April 27, 1990

RE: Property located at 19327 Mary Ardrey Circle
FILE: 5700A
PARCEL: 001-511-34

Receipt of your plans for a modified waste disposal system for the property referenced above is acknowledged.

WILLIAM KIMBROUGH
MARY ARDREY CIRCLE - LOT 15
FILE NO. 5700A - PARCEL 001-511-34
PATRICK'S PURCHASE, PHASE II
MECKLENBURG COUNTY, N.C.

T&J PANEL SYSTEM
PATRICK'S PURCHASE PH. II
MARY ARDREY CIRCLE
MECKLENBURG, CO. NC
LOT #15

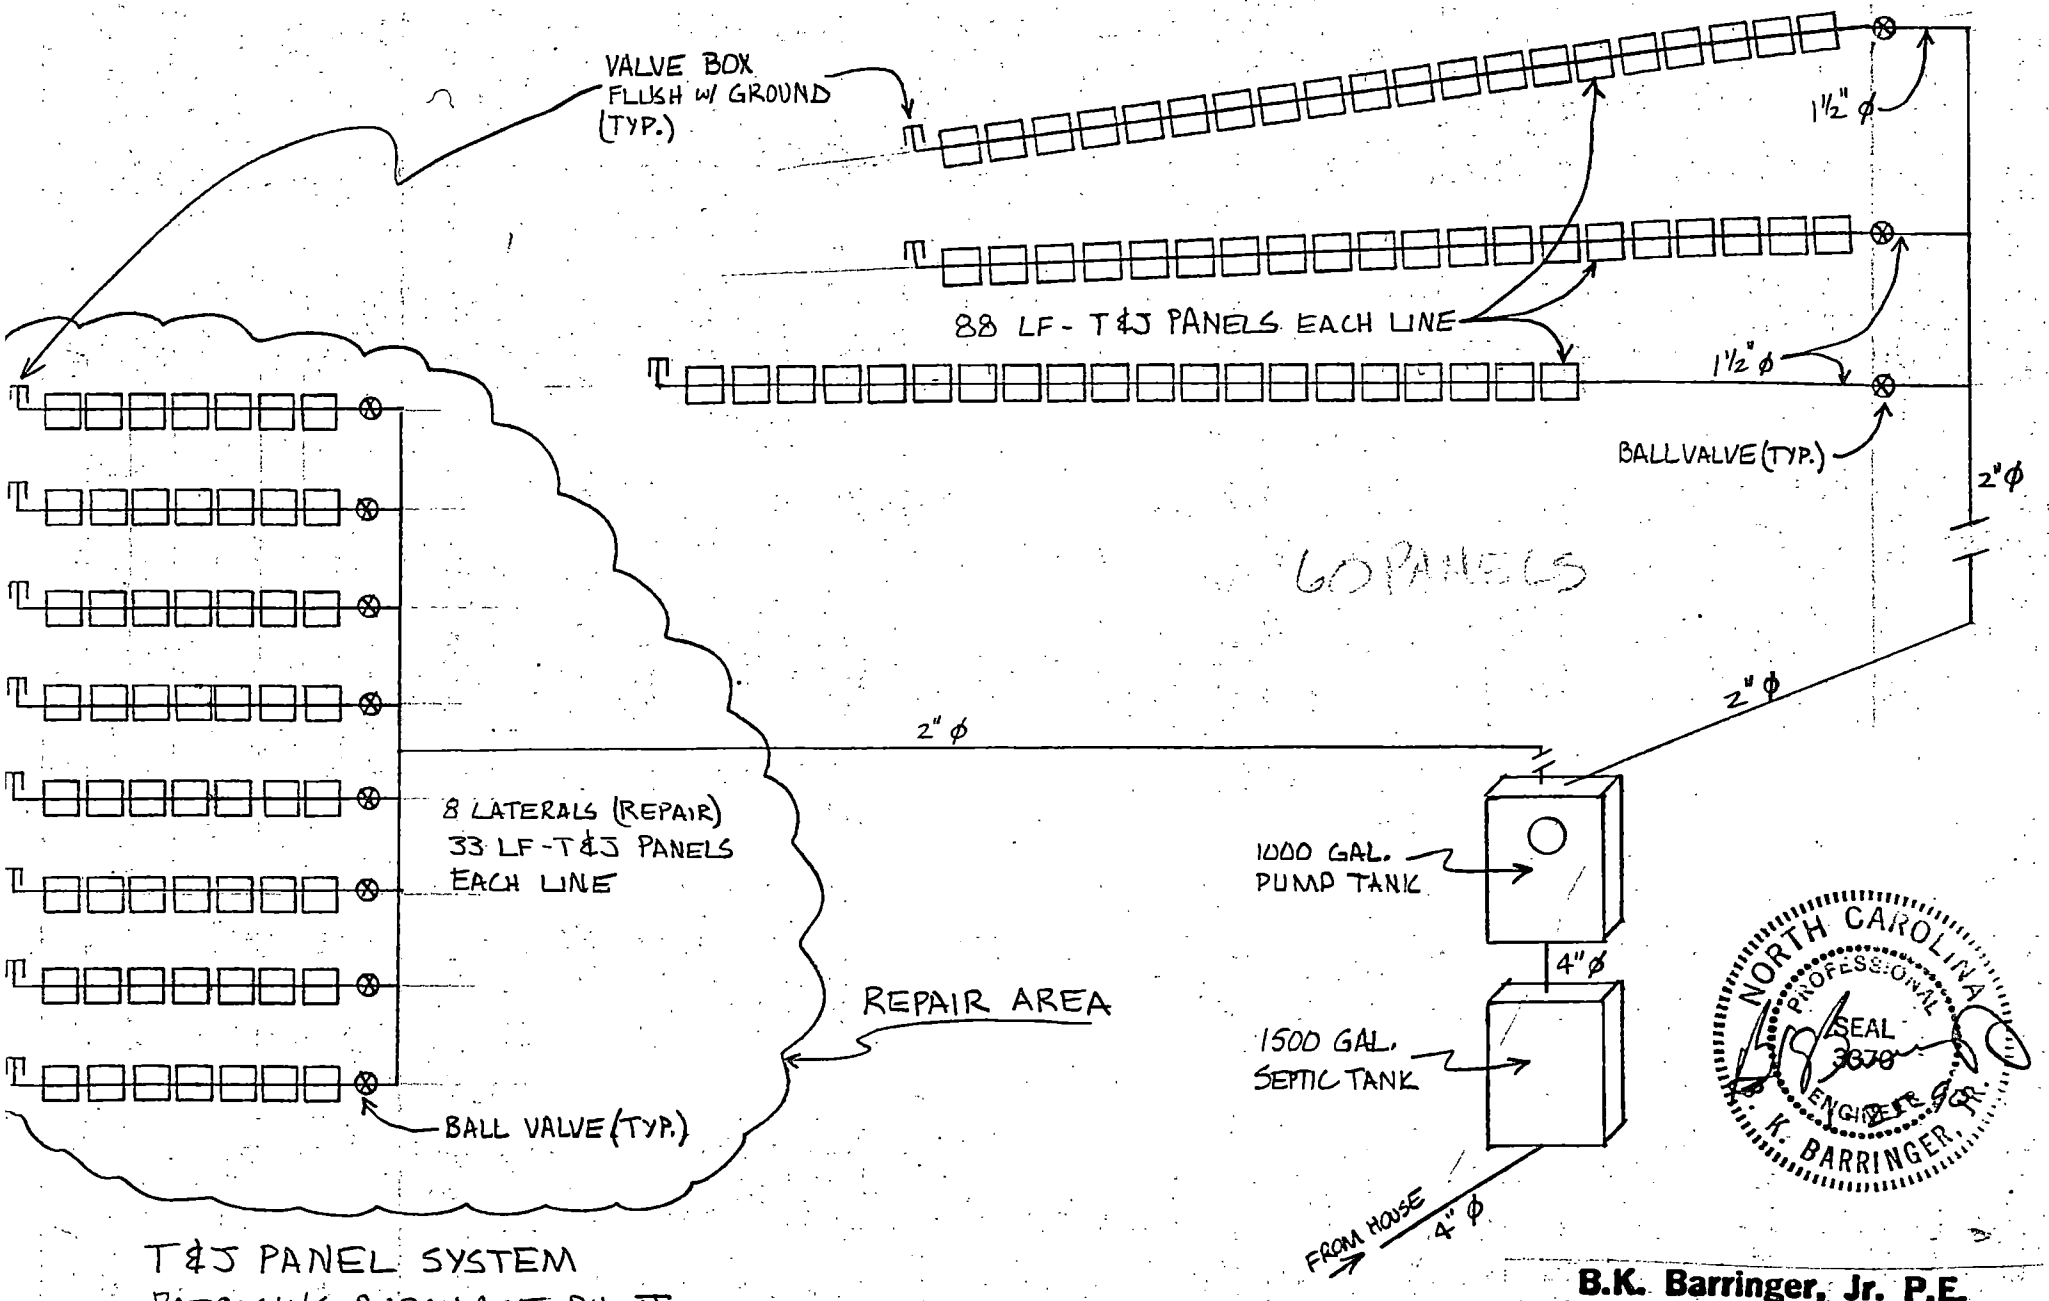
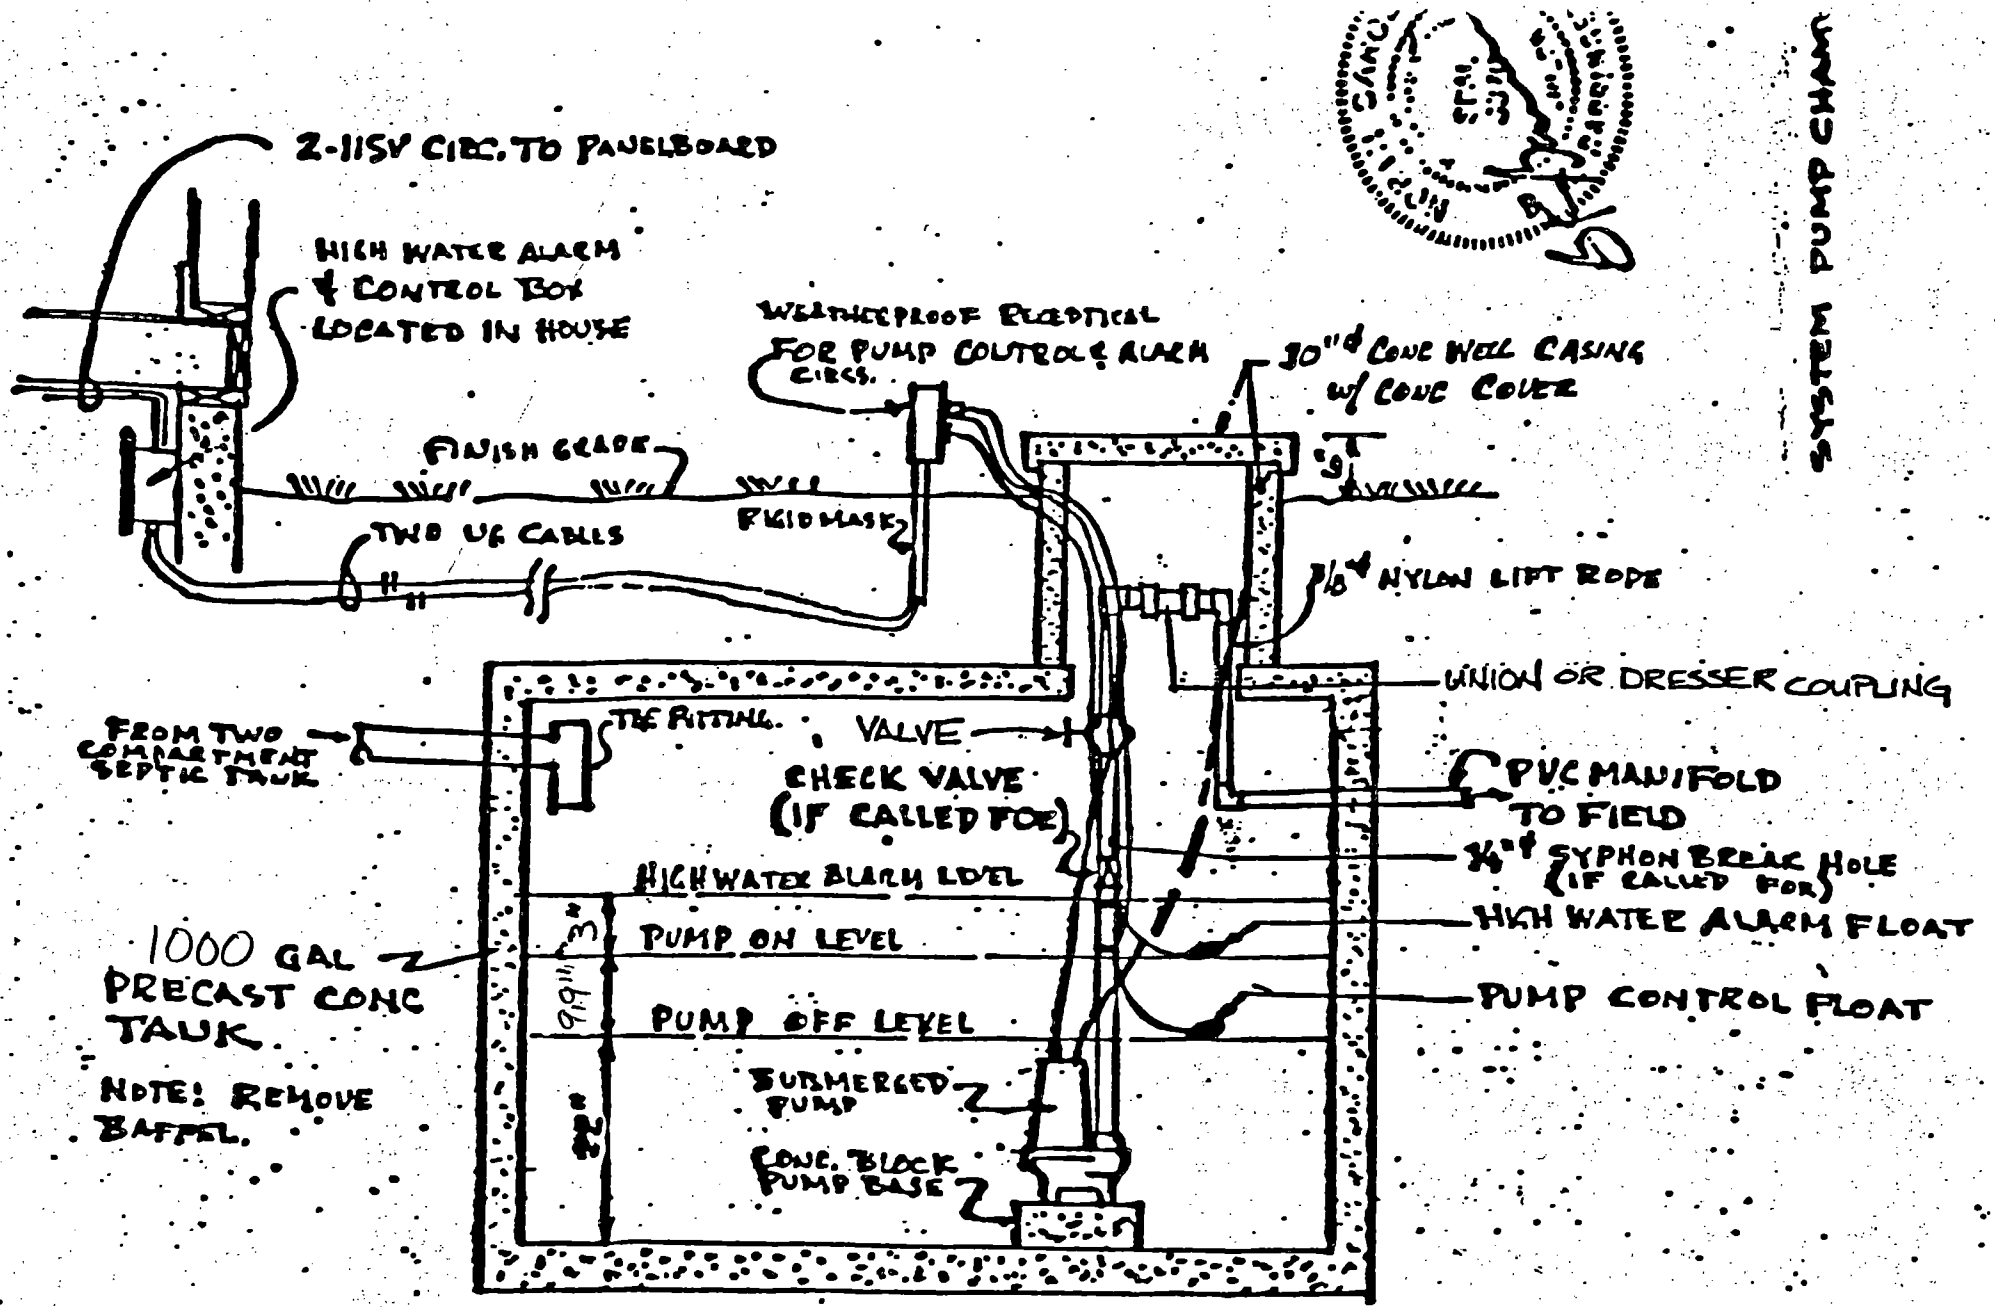
Your plans for the modified system for the above property as submitted are approved with the following comments:

- The well should be located 100 feet or no less than 50 feet away from any part of the sewage disposal system and repair area.
- Water saving plumbing devices and low flush toilets should be installed when constructing the residence.
- Occupants to utilize maximum water conservation measures wherever possible.
- Effectively rake and lime all trench sidewalls
- Landscaping of repair area to be undisturbed. No grading, shaping, or altering in anyway.
